Access Compliance Report Public Rights-of-Way (Curb Ramps)

Main Street: IRISH_MOSS_ST Cross Street: N/A Location: NW

ADA ID: RPRK211122123240 Ramp Type: Type 4 - Parallel Initial Pass/Fail: Fail Overall Compliance: No Severity Score: 2

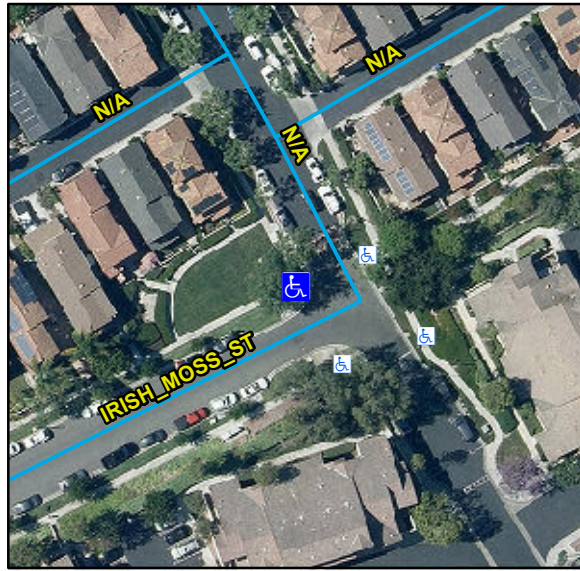
Compliance	Description	Data	Compliance	Description	Data
N/A	Ramp Length LT (in)	133	N/A	Ramp Length RT (in)	132
Yes	Ramp Width LT (in)	53	Yes	Ramp Width RT (in)	53
Yes	Ramp Run Slope LT (%)	5.4	Yes	Ramp Run Slope RT (%)	6.3
Yes	Ramp Cross Slope LT (%)	1.4	No	Ramp Cross Slope RT (%)	2.3
N/A	Landing Present	N/A	N/A	DWS Provided	N/A
N/A	Landing Length (in)	N/A	N/A	DWS Contrast	N/A
N/A	Landing Width (in)	N/A	N/A	DWS Length (in)	N/A
N/A	Landing Run Slope (%)	N/A	N/A	DWS Full Width	N/A
N/A	Landing Cross Slope (%)	N/A		DWS Offset Type	N/A
N/A	Landing Movement Obstructed?	N/A	N/A	DWS Offset Left (in)	N/A
	Landing Movement Type	N/A	N/A	DWS Offset Right (in)	N/A
N/A	Landing Shared	N/A			
N/A	Clear Space	Yes			
N/A	Clear Space To Crosswalk (in)	N/A			
N/A	Marked Crosswalk 1	No	N/A	Marked Crosswalk 2	No
	Crossing 1 Direction	SE		Crossing 2 Direction	NE
	Marked Crosswalk 1 Width (in)	N/A		Marked Crosswalk 2 Width (in)	N/A

Remove & Replace Curb Ramp With Two New Directional Ramps or Equivalent.
